## **ZONING CHANGE REVIEW SHEET**

**CASE:** C814-2017-0001 – 425 W. Riverside PUD

**ADDRESS:** 425 W. Riverside Drive

**ZONING FROM:** CS-1-V-NP      **TO:** PUD-NP

EXHIBIT F - LAND USE PLAN-OPEN SPACE

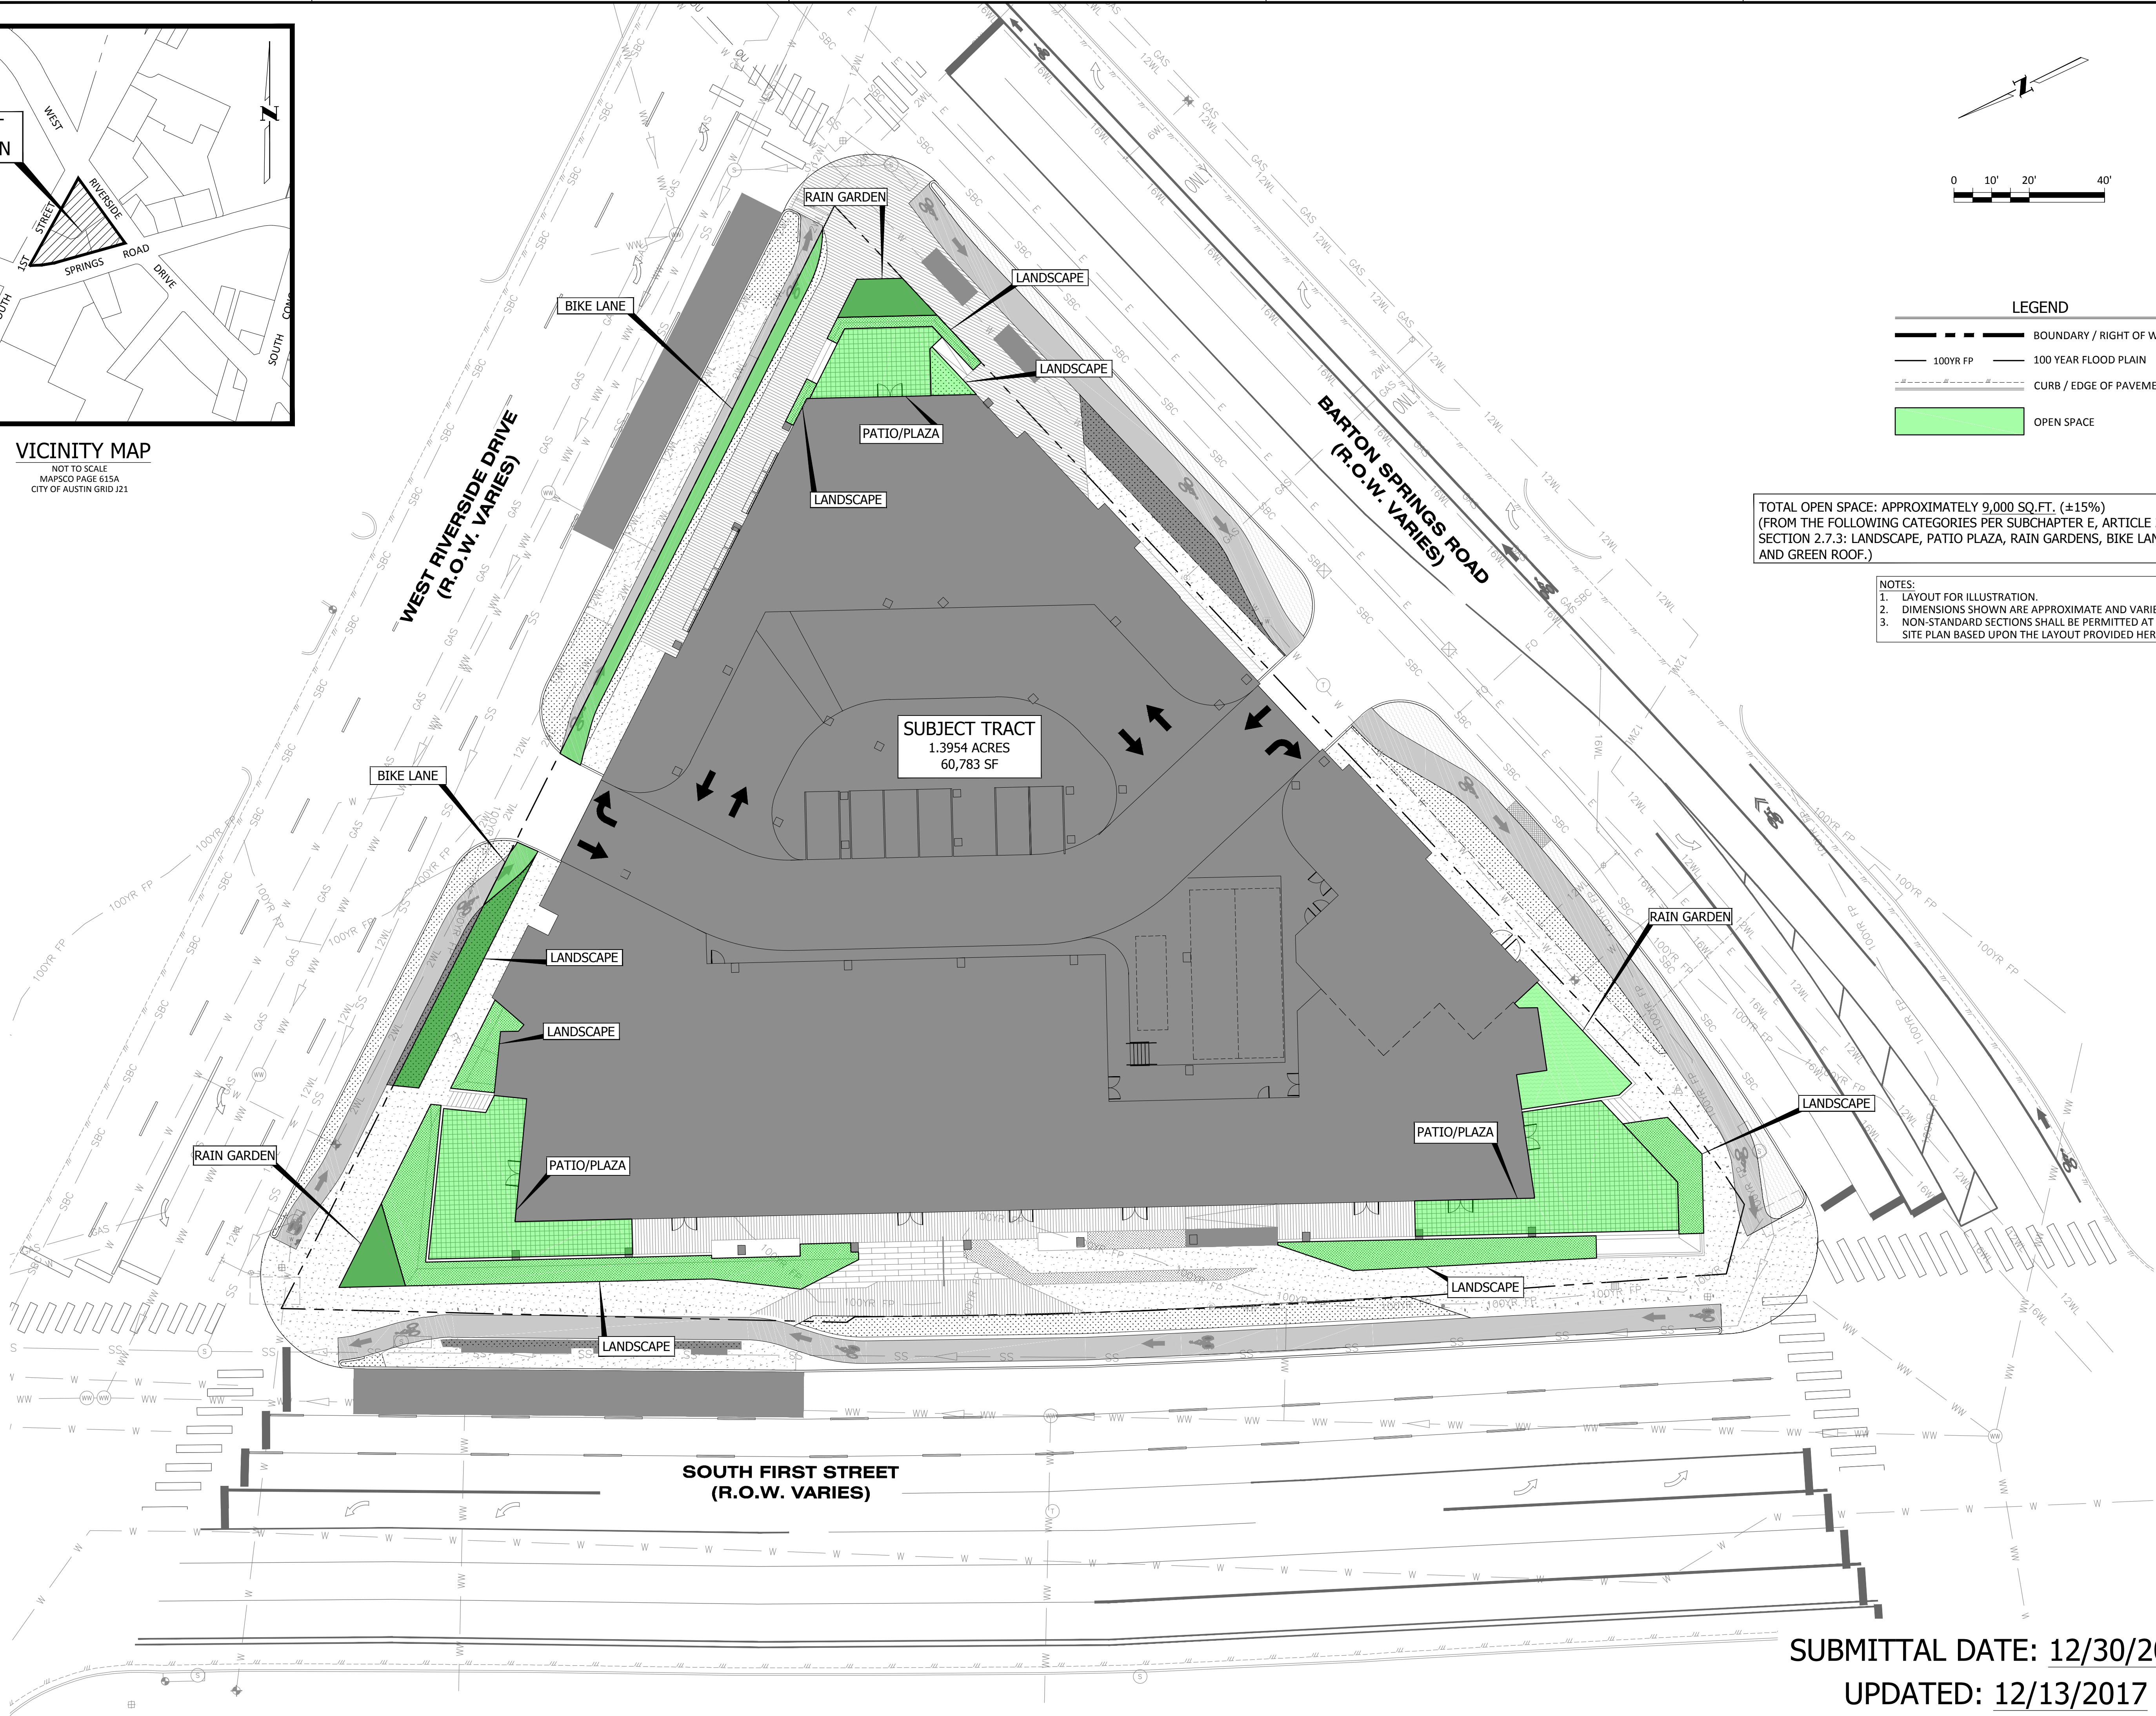
**U3: The proposed Open Spaces A, B, C, and D (green roof) are acceptable, as is the minimum commitment of 15% of the site. However, please prepare an open space exhibit that can be included with the PUD ordinance. (Something like the submitted exhibit can be used, but it currently says “for informational purposes only – Update 2”). This comment can be cleared informally.**

EXAMPLE TREEWELL  
AXONOMETRIC VIEW NOT TO SCALE 03

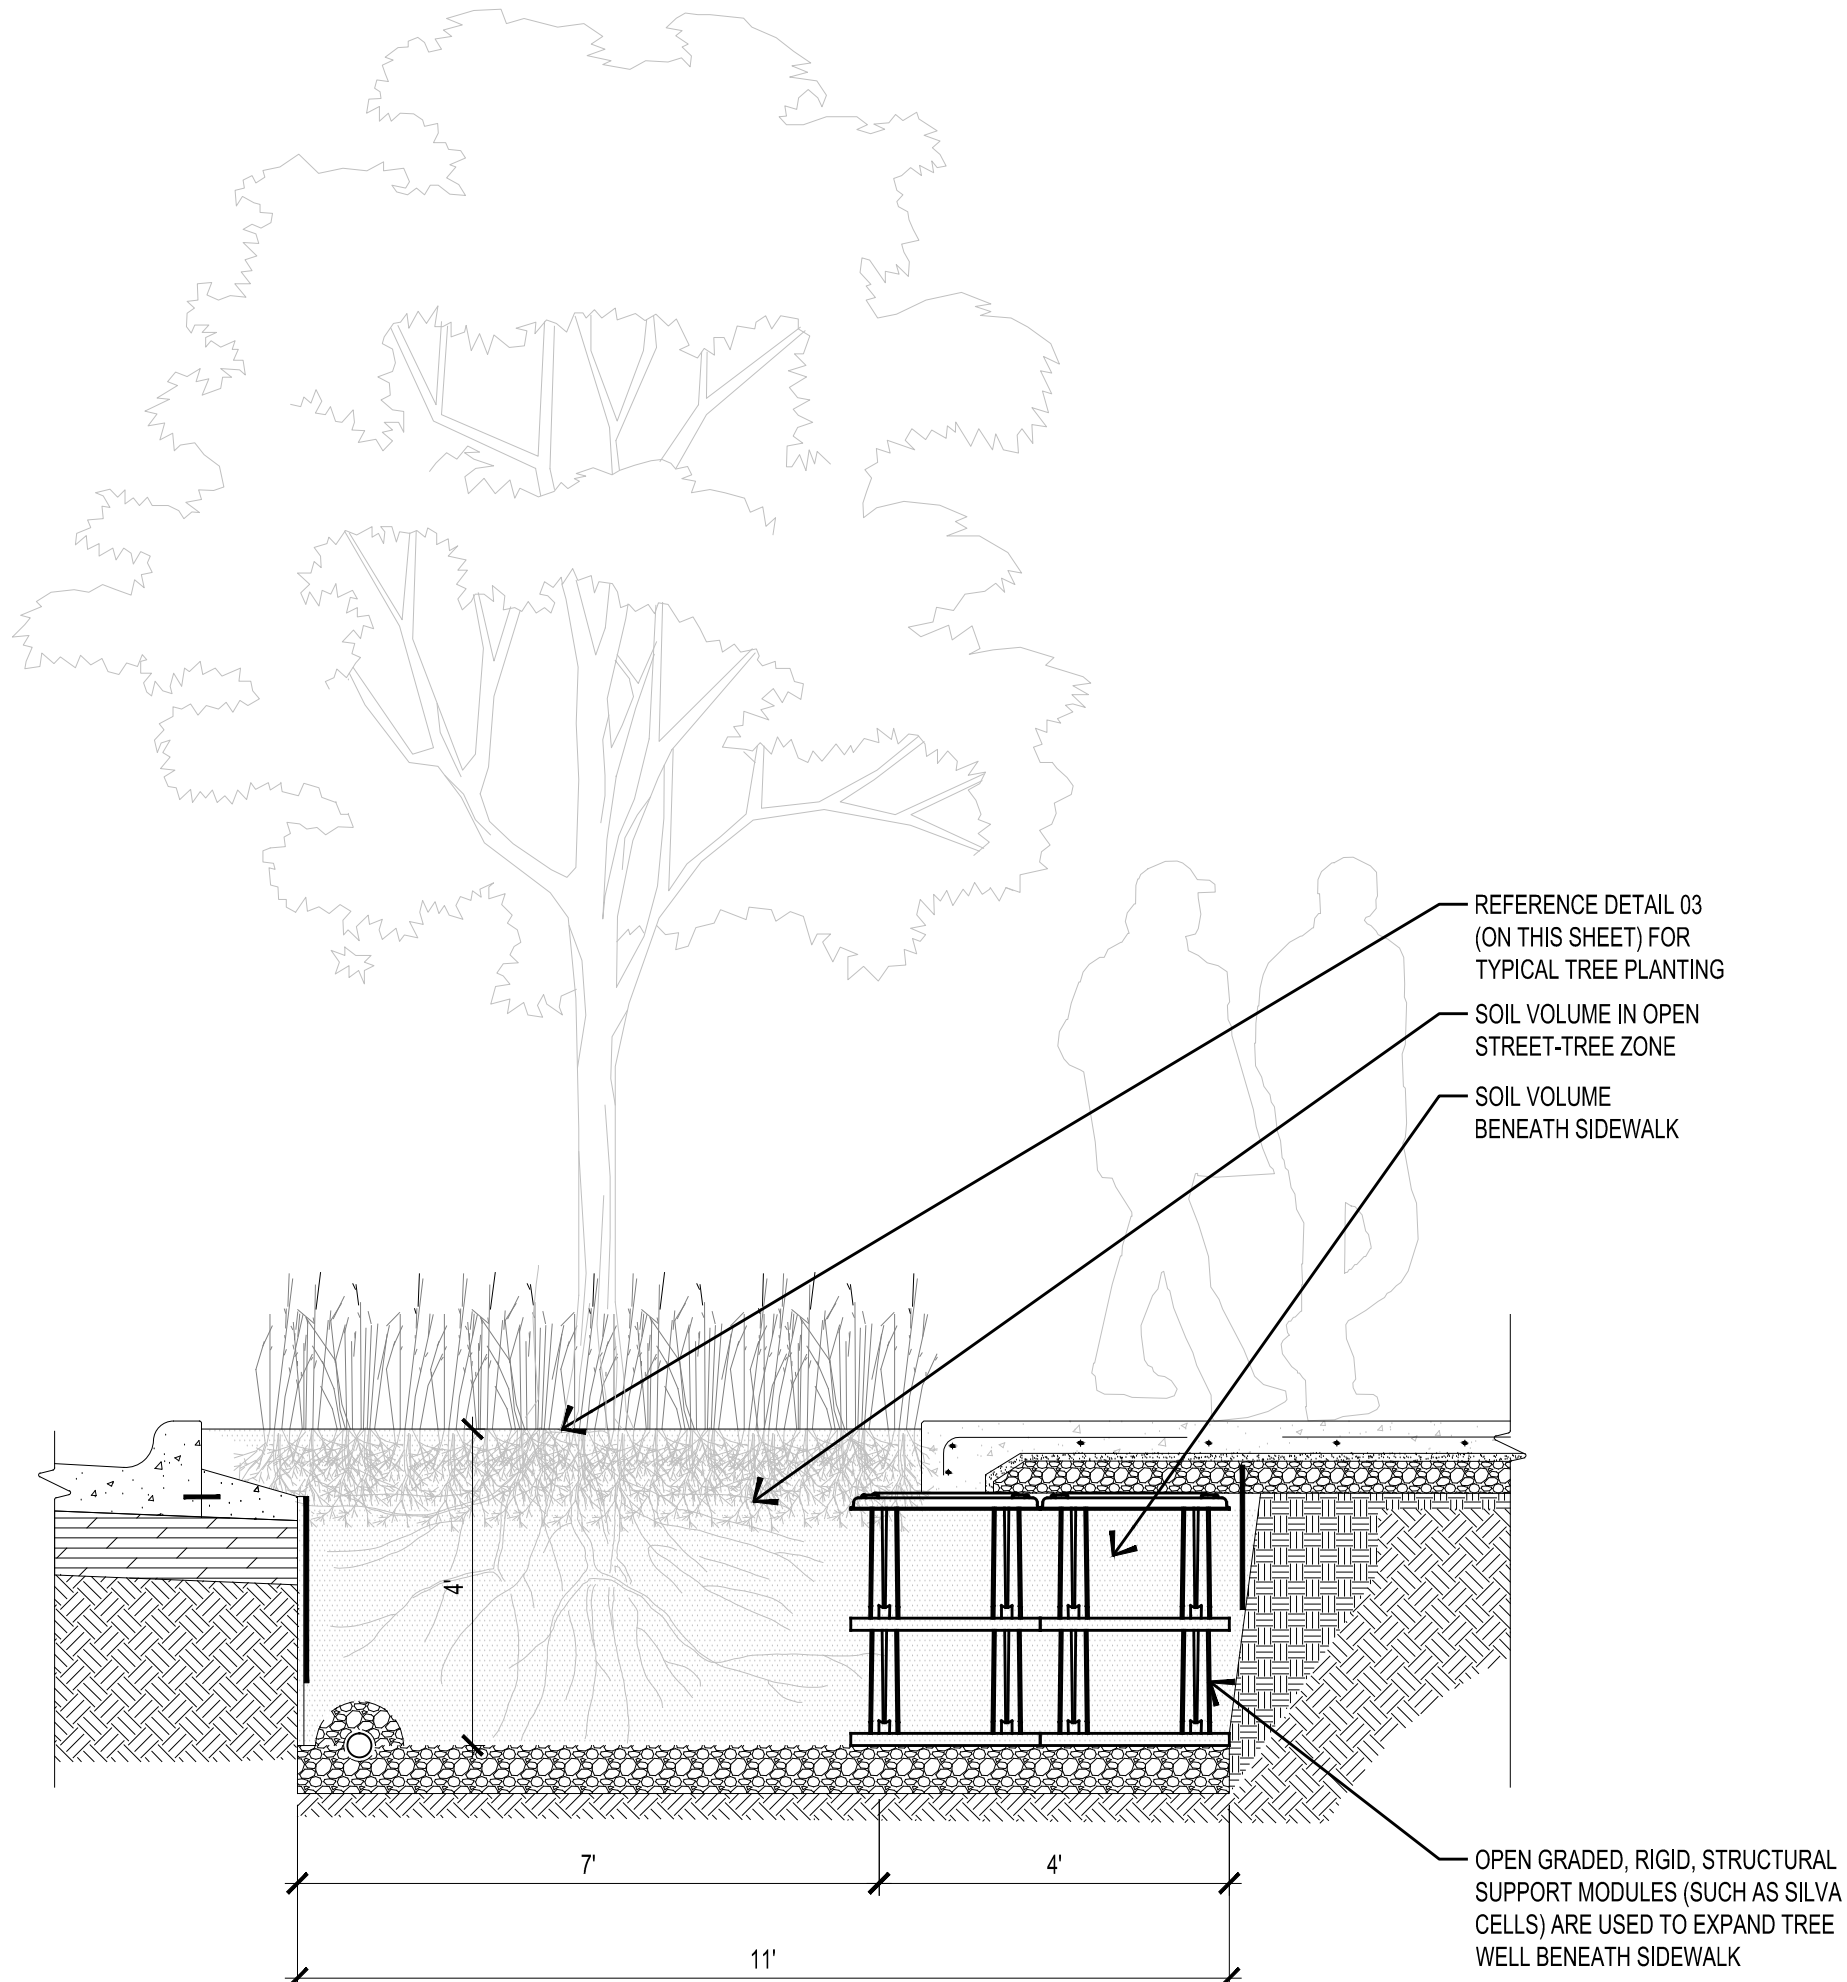
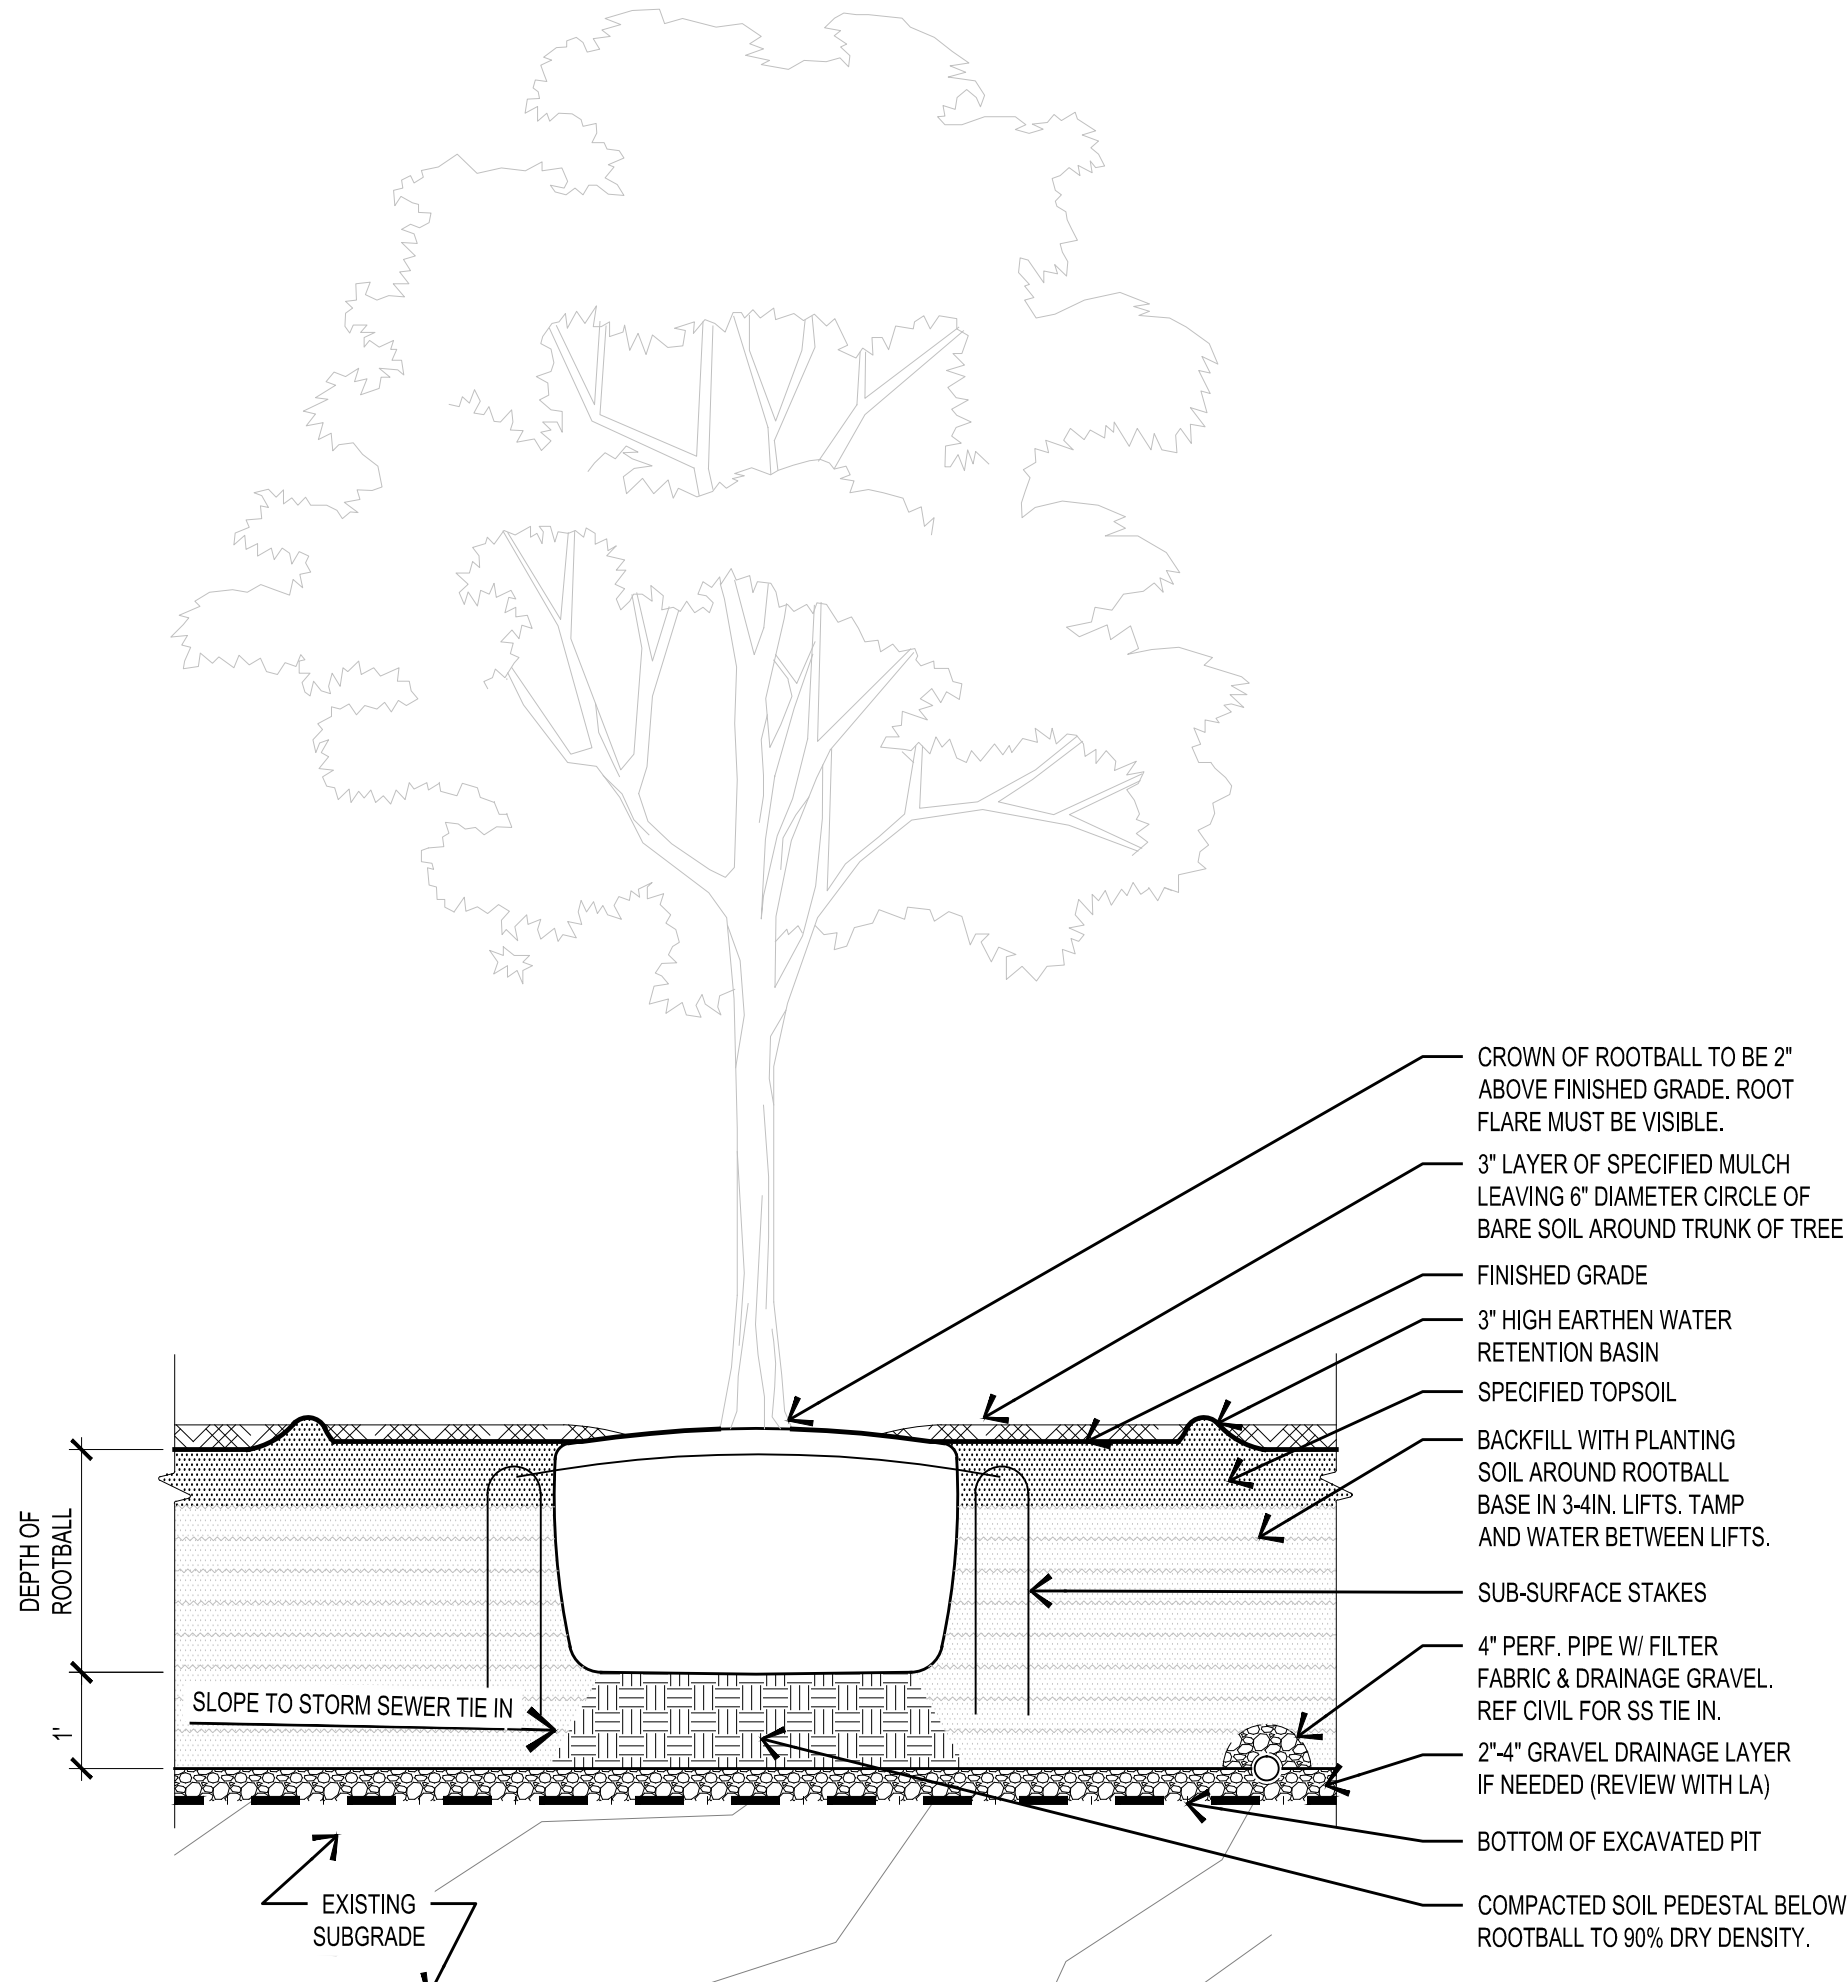
**Please also revise your soil commitments and notes to be consistent with the last update. These should include the larger 1540 CY soil volume required in locations other than ones with utility conflicts. In those cases where it is proven utility conflict then 1000 CY minimum is accepted with the use of soil cells. Comment pending.**

EO8. Please confirm whether it is feasible to acquire 5” caliper Appendix F street trees using Central Texas seed stock. Please provide additional details about the soil volume proposed for the street trees; staff’s preference for large trees is 1,500 cubic feet of soil.

U1: A commitment to use Central Texas seed stock is not the same as planting native species. Please confirm with the Heritage Tree reviewer that it is possible to find 5” caliper trees of the selected species that have been raised locally. In staff’s experience, tree stock of the selected species is grown elsewhere. Please specify the minimum soil volume to be provided for the street trees, and provide additional information about how that volume will be achieved. This may require a commitment to using Silva cells.
